TOWN OF HOLLIS, NEW HAMPSHIRE

Farley Building

WEATHER TIGHT ENVELOPE/EXTERIOR CONDITION ASSESSMENT & STABILIZATION PLAN

Prepared by the Hollis Heritage Commission, Richard Brown & John Butler July 2012, Revised December 2012

FARLEY BUILDING: SOUTH & NORTH ELEVATIONS, CONDITION ASSESSMENT JULY 2012 **REVISED NOV. 2012** SHEET 8 OF 10

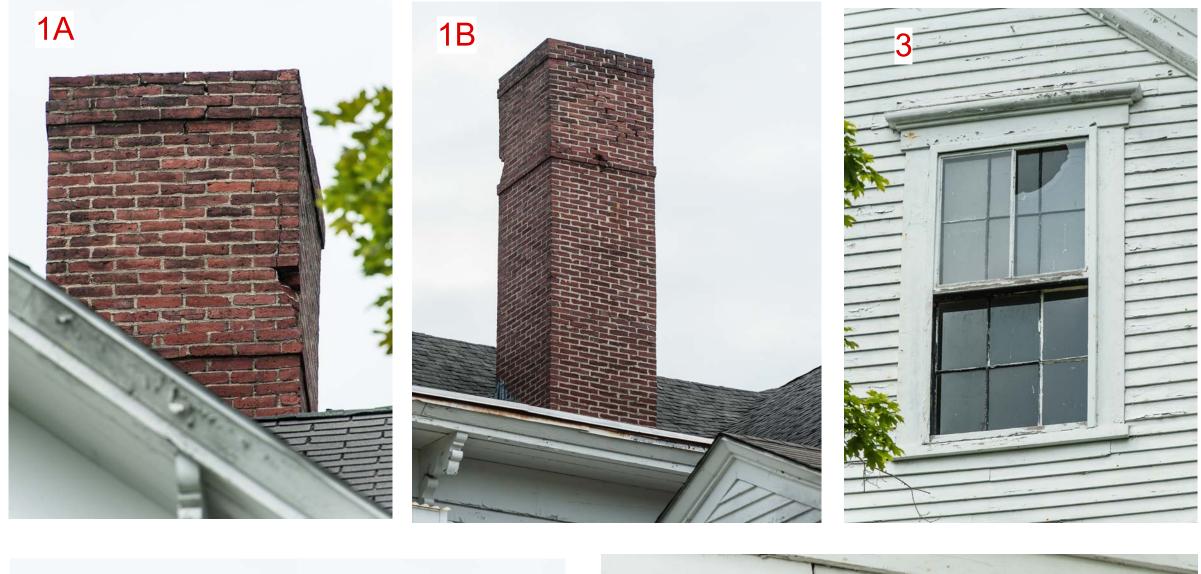
2B. MISSING ROOF SHINGLE, (SEE DETAIL IMAGE). STABILIZATION RECOMMENDATION: REPAIR/REPLACE MISSING/DAMAGED

SHINGLE. 3. EAST ELEVATION GABLE WINDOWS: RIGHT WINDOW; LOWER STORM SASH MISSING, UPPER STORM SASH BROKEN, (SEE DETAIL IMAGE). STABILIZATION RECOMMENDATION: INSTALL/REPAIR STORM SASH. 5. TREES IN TOO CLOSE PROXIMITY

TO THE BUILDING. STABILIZATION RECOMMENDATION:

REMOVE BOTH TREES. 8. SIGNIFICANT AREAS OF PAINT LOSS/FAILURE ON BOTH THE SOUTH & EAST ELEVATIONS, IN MANY CASES PAINT FAILURE HAS EXPOSED THE

VOOD SUBSTRATE. STABILIZATION RECOMMENDATION: PAINT PRIME AREAS OF BARE WOOD WITH OIL BASED PRIMER. 9. DETERIORATED WOOD LATTICE SLATS SHOULD BE REMOVED OR DEDUACED

REPLACED.

STABILIZATION RECOMMENDATION: NO ACTION AT THIS TIME. 10. MISSING BALASTRADE PARTS, REPLACE FOR POSSIBLE SAFETY ISSUES.

STABILIZATION RECOMMENDATION: NO ACTION AT THIS TIME.
